Selland Arena - Auditorium  
 700 M Street, Fresno

Selland Arena (SA)

Seland Arena - Balcony Floor  
700 M Street, Fresno

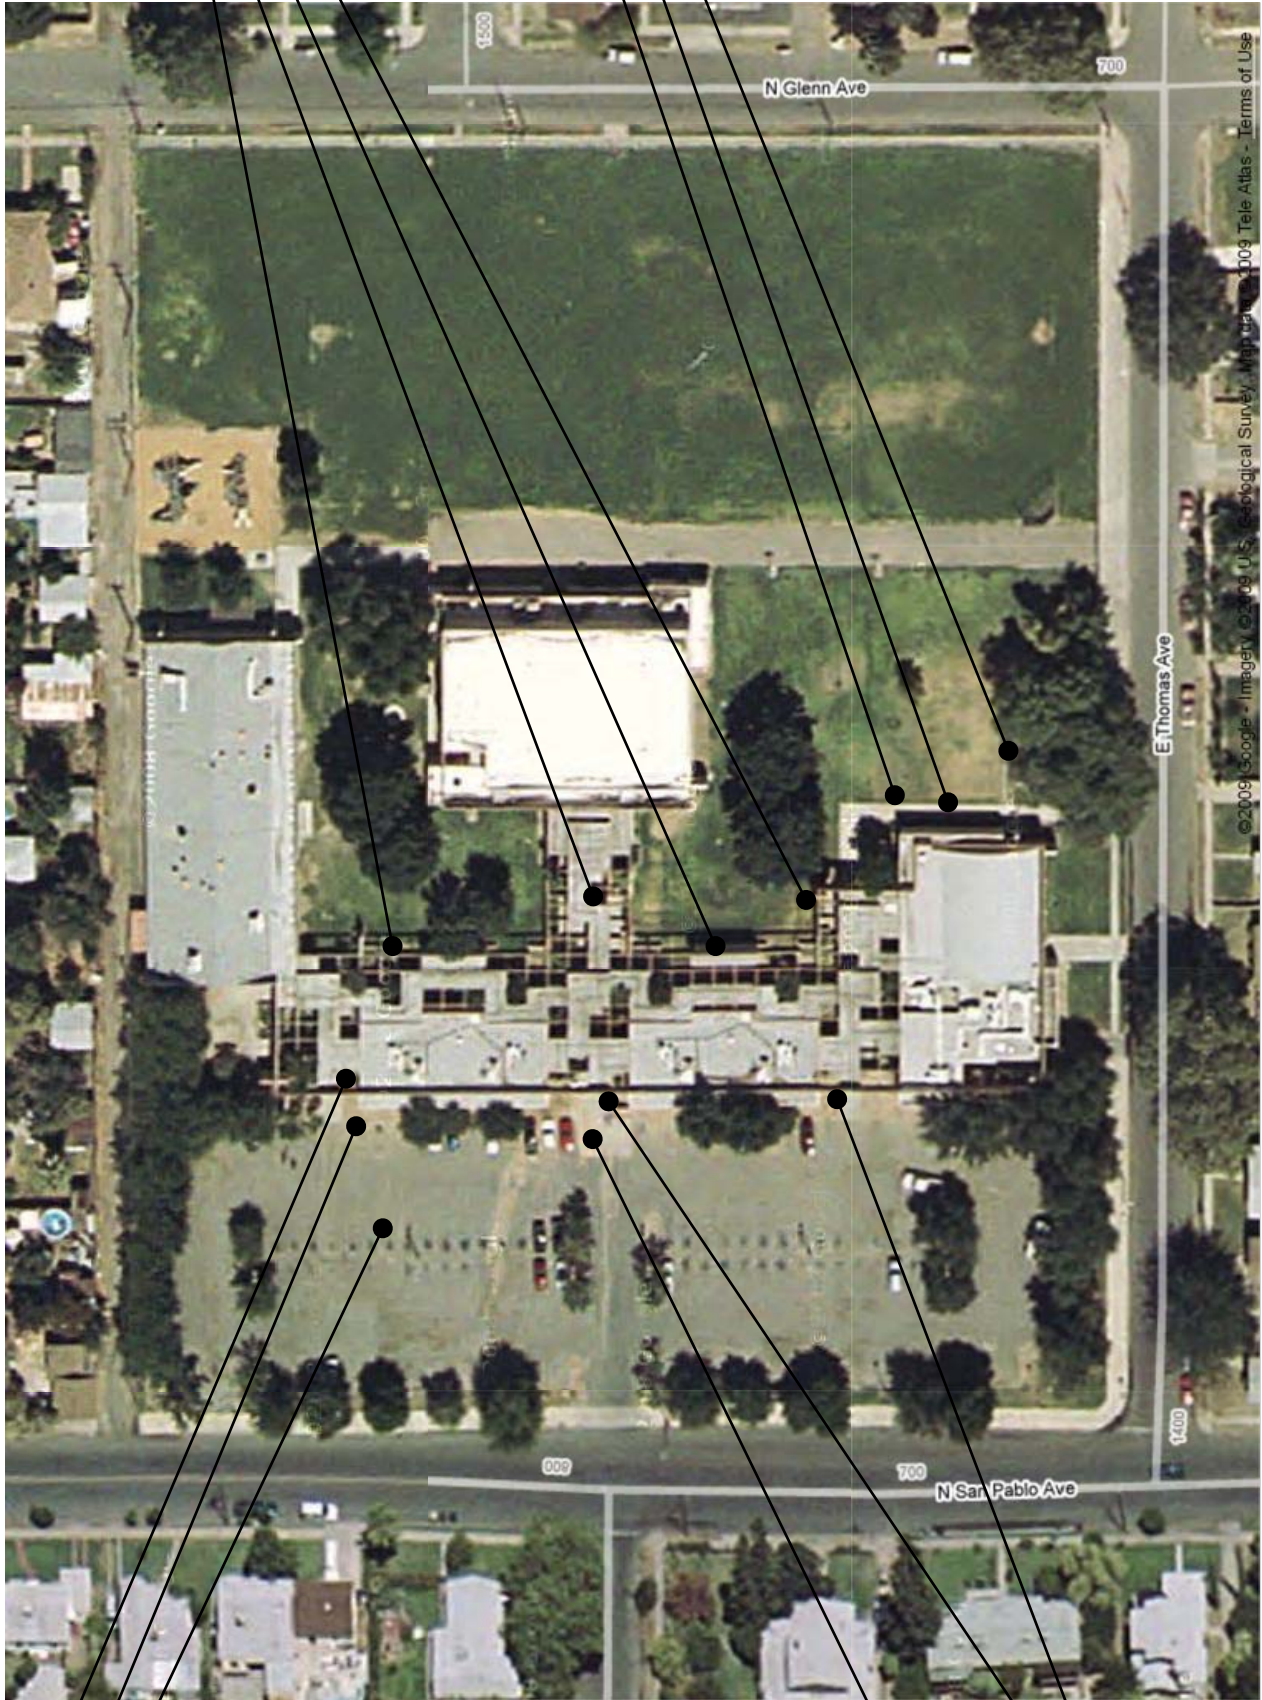
Notes: Drain pipes are not insulated.	
State: 1115B.4.3 #4	
Federal: 4.19.4	
<b>Reposition controls and outlets</b>	<b>\$250</b>
Notes: Center of the grip of the operating handle of light switch is 49-3/4" (48") AFF.	
State: 1117B.6 #5	
Federal: -	
<b>Replace or reposition fixtures</b>	<b>\$1,000</b>
Notes: Space from the wall to the centerline of the toilet is 19-7/8" (18" req).	
State: 1115B.7.1.3	
Federal: 4.17.3

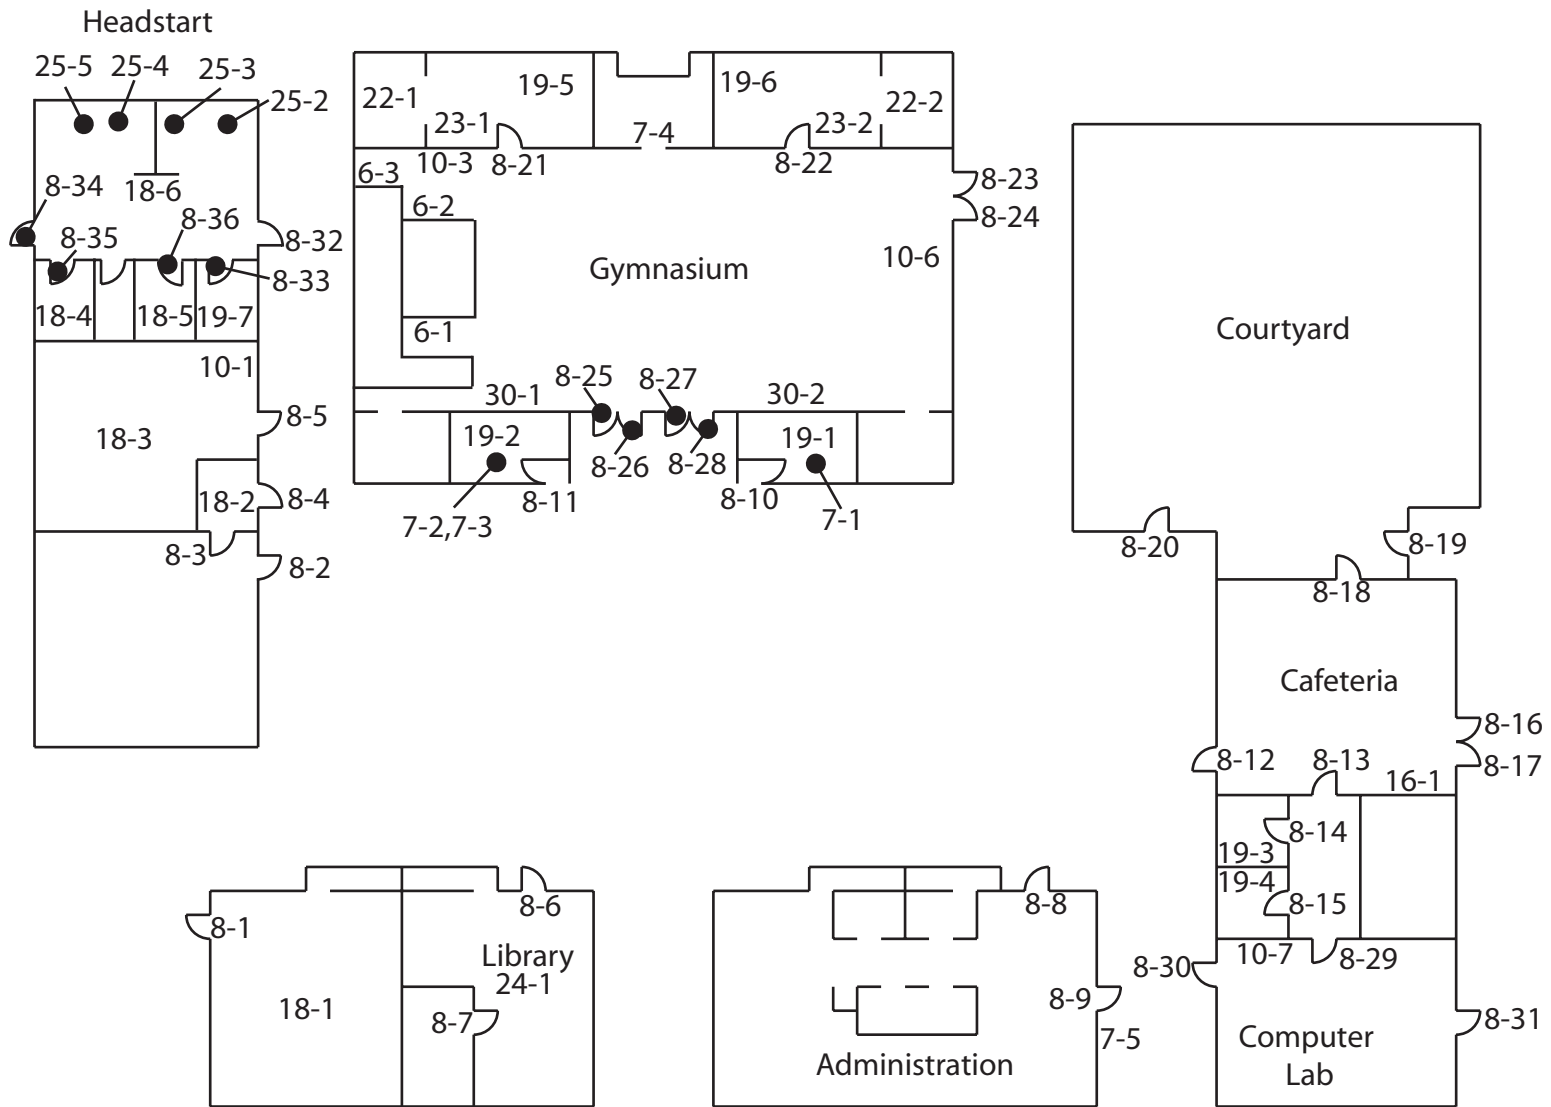
<b>Exterior</b>	
<b>32 - 1 Picnic Area</b>	Priority: C
<b>Provide an accessible table</b>	\$1,000
Notes: Knee space under the tabletop is 18-3/4" (19" min) deep. Toe clearance is not provided.	
State: -	
Federal: 306.3	
<b>Regrade surface</b>	\$1,800
Notes: Slope is 3.7% (2% max).	
State: 1133B.5.3.1	
Federal: 4.8.6	
<b>32 - 2 Picnic Area</b>	Priority: C
<b>Provide an accessible table</b>	\$1,000
Notes: Knee space under the tabletop is 18-3/4" (19" min) deep. Toe clearance is not provided.	
State: -	
Federal: 306.3	
<b>Regrade surface</b>	\$1,800
Notes: Slope is 3.7% (2% max).	
State: 1133B.5.3.1	
Federal: 4.8.6	
<b>32 - 3 Picnic Area</b>	Priority: C
<b>Provide an accessible table</b>	\$1,000
Notes: Knee space under the tabletop is 13" (19" min) deep. Knee space is 29" (30" min) wide. Toe clearance is not provided.	
State: -	
Federal: 306.3	
<b>Regrade surface</b>	\$1,800
Notes: Slope is 3.7% (2% max).	
State: 1133B.5.3.1

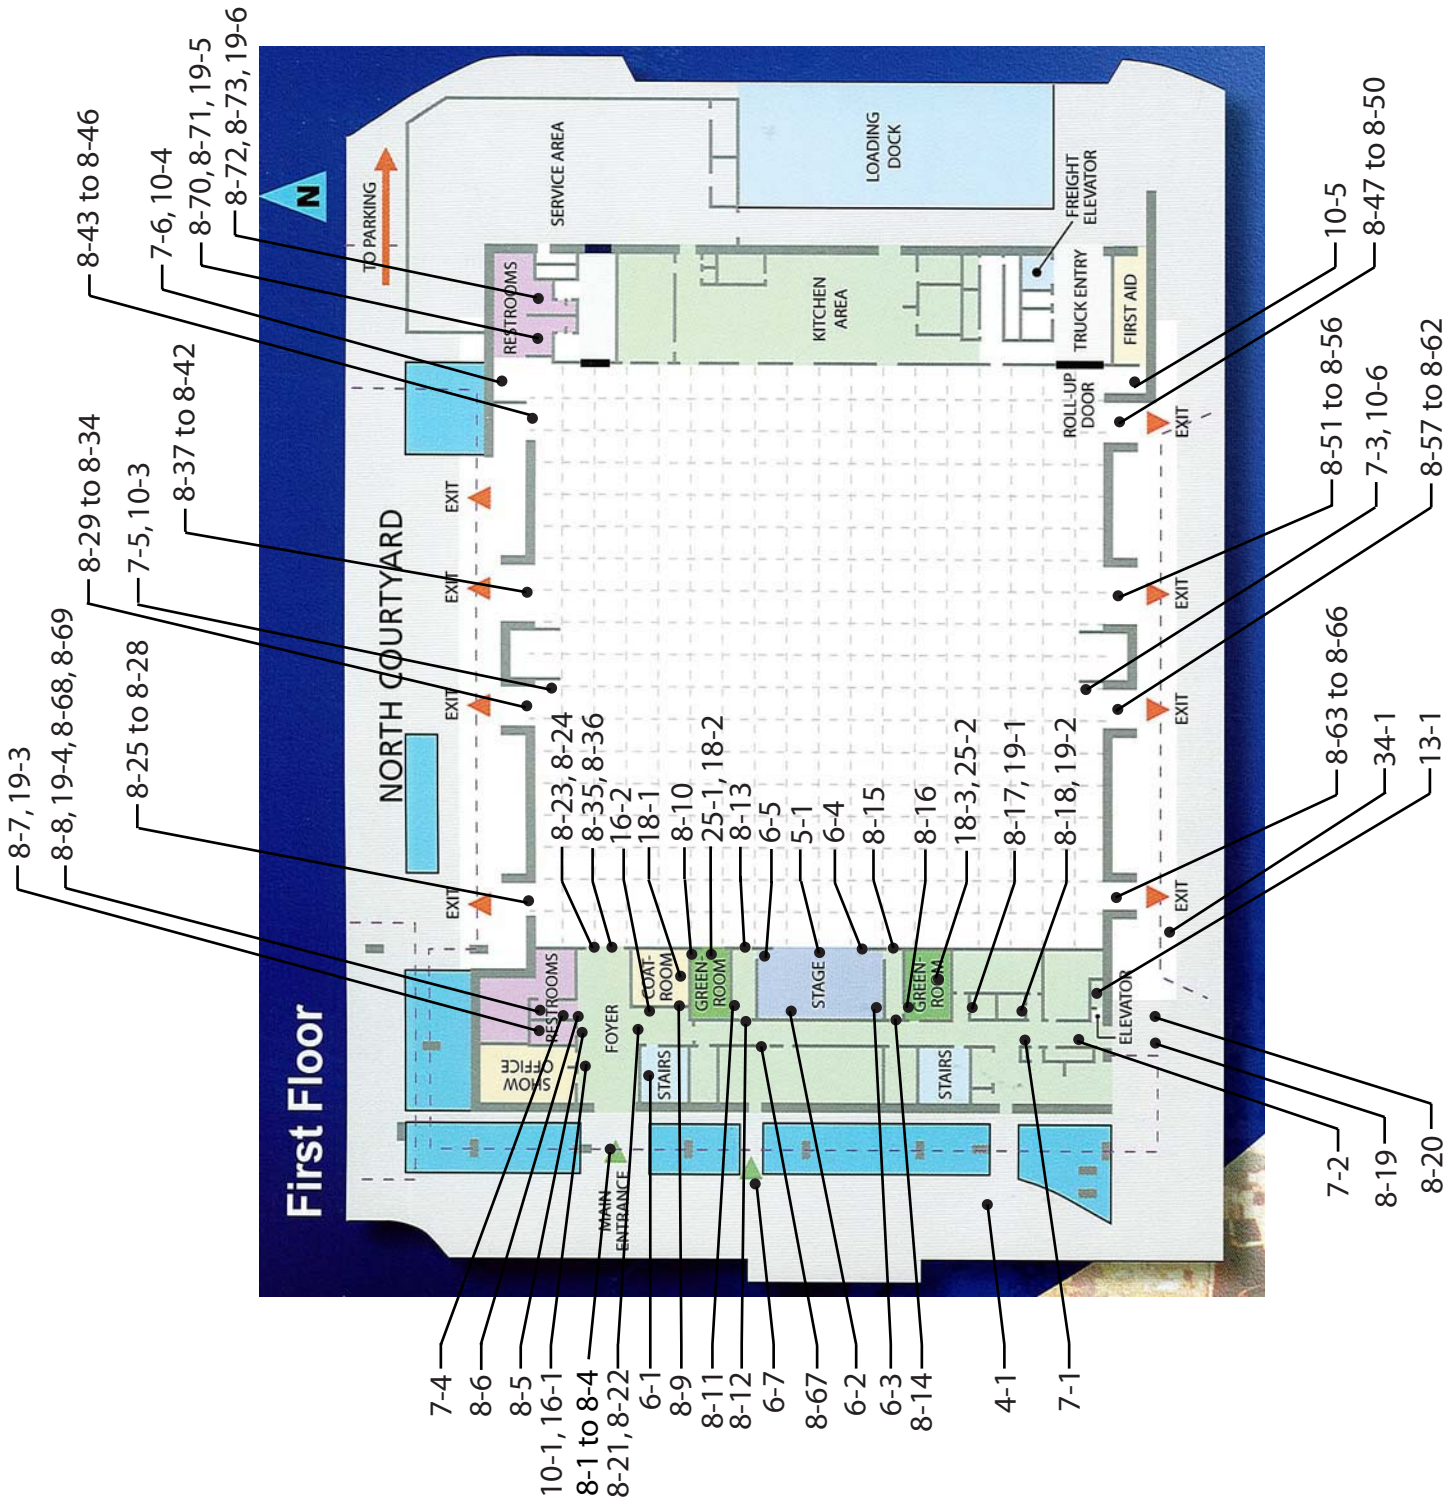
<b>Floor 1</b>		
<b>23 - 1</b>	<b>Locker Room</b>	Priority:2
<b>Provide accessible seating</b>		\$250
Notes: Fixed bench is 17-1/2" (24" min) x 48".		
State: 1117B.8		
Federal: 4.37.3		
<b>Provide accessible lockers</b>		\$500
Notes: Accessible locker hardware requires pinching.		
State: -		
Federal: -		
<b>23 - 2</b>	<b>Locker Room</b>	Priority:2
<b>Provide accessible seating</b>		\$250
Notes: Fixed bench is 17-1/2" (24" min) x 48".		
State: 1117B.8		
Federal: 4.37.3		
<b>Provide accessible lockers</b>		\$500
Notes: Accessible locker hardware requires pinching.		
State: -		
Federal: -		
<b>24 - 1</b>	<b>Library</b>	Priority:4
<b>Widen aisles</b>		\$1,000
Notes: Main aisles are 40" (44" min) wide.		
State: 1106B.4 #2		
Federal: 8.5		
<b>Adjust shelving, storage, or work space</b>		\$1,000
Notes: Bookshelf height is 84" (54" max).		
State: 1106B.4 #3		
Federal: 8.4

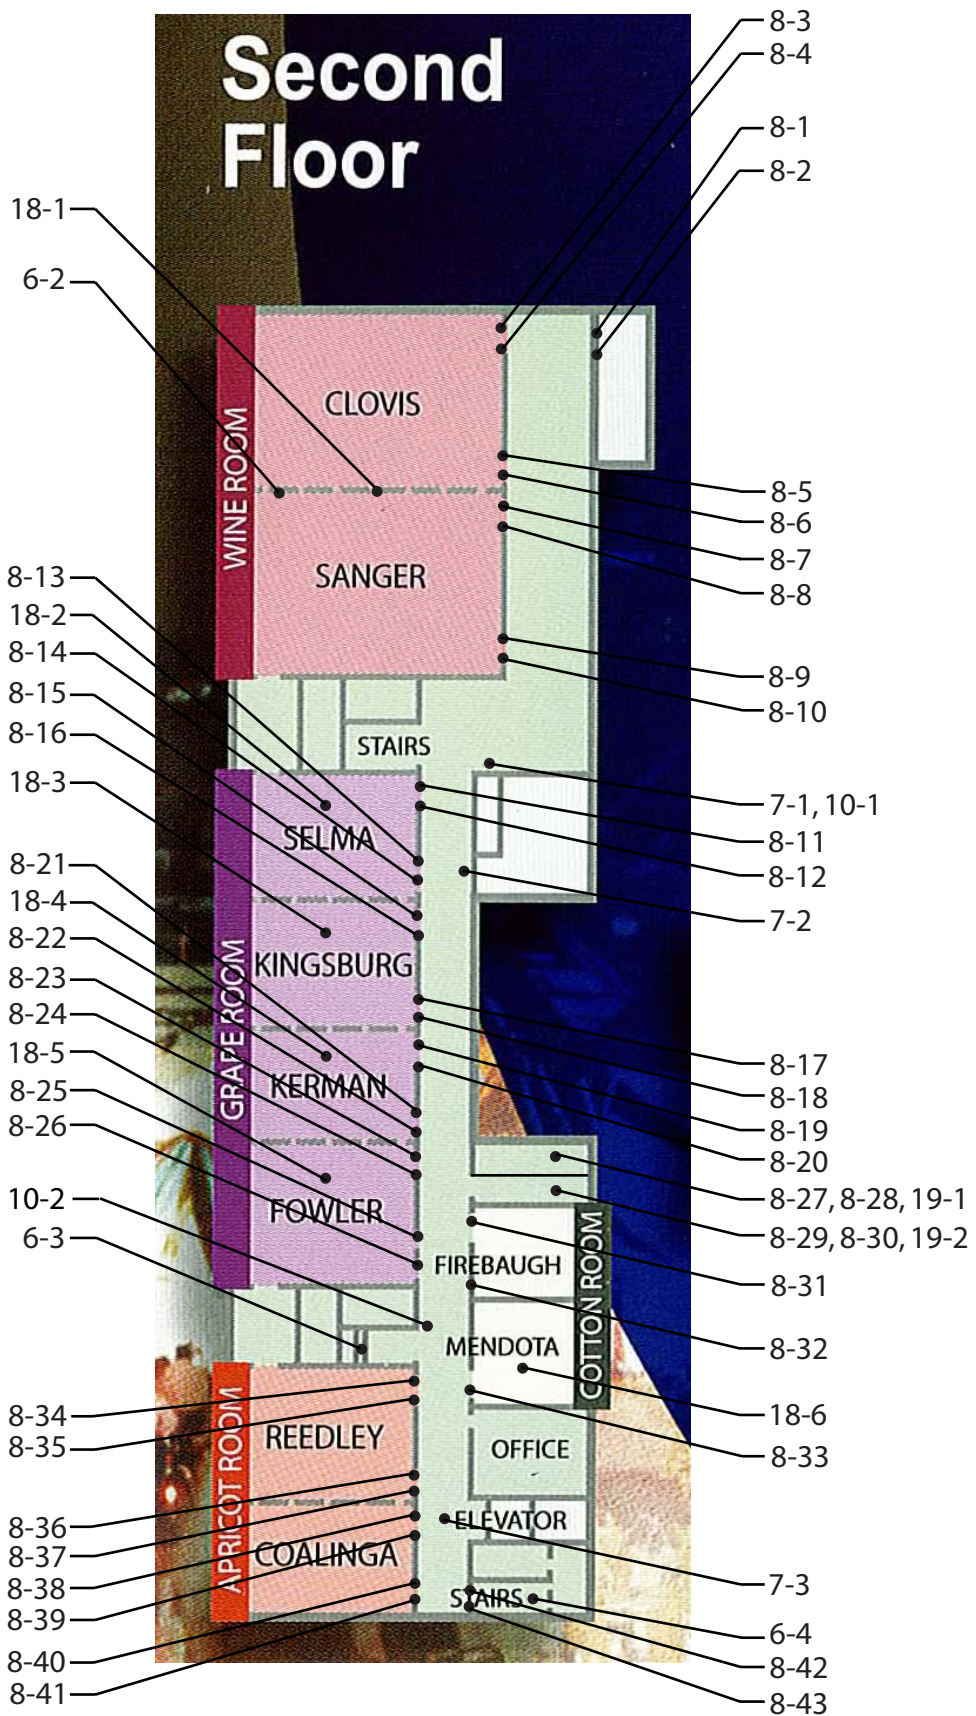
<b>Reposition controls and outlets</b>	<b>\$250</b>
Notes: Light switch is 53" (36" to 48" max) above the finished floor. Clear floor space of 30" x 48" is not provided in front of light switch.	
State: 1117B.6 #2, 1117B.6 #5	
Federal: 4.2.4.2	
<b>Provide or replace stall door hardware</b>	<b>\$100</b>
Notes: Stall door does not have U-shaped handle on the back.	
State: 1115B.3.1 #4.5	
Federal: 4.13.9	
<b>Replace or reposition fixtures</b>	<b>\$1,000</b>
Notes: Space from the wall to the centerline of the toilet is 16" (18" req).	
State: 1115B.7.1.3	
Federal: 4.17.3
